# Access Compliance Report

## Public Rights-of-Way

### (Curb Ramps)

Intersection ID: 10040760	Main Street: W_TYVOLA_RD	Cross Street: N/A	Location: E
ADA ID: B48869274B63	Ramp Type: Perp	Initial Pass/Fail: Pass	Overall Compliance: No
Severity Score: 0			
Codes/Mitigation Info/Possible Solution		Field Measurements/Component Compliance

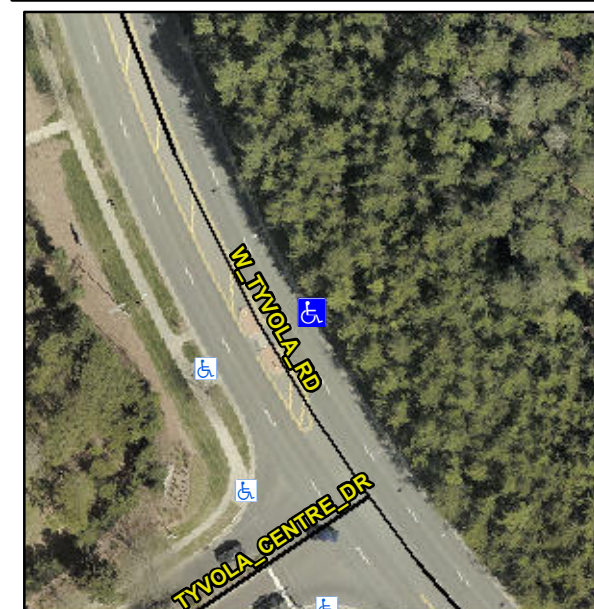
**R304.2.2-Perp, R304.3.2-Para,  
R304.5.3**

**Remove & Replace Landing.**
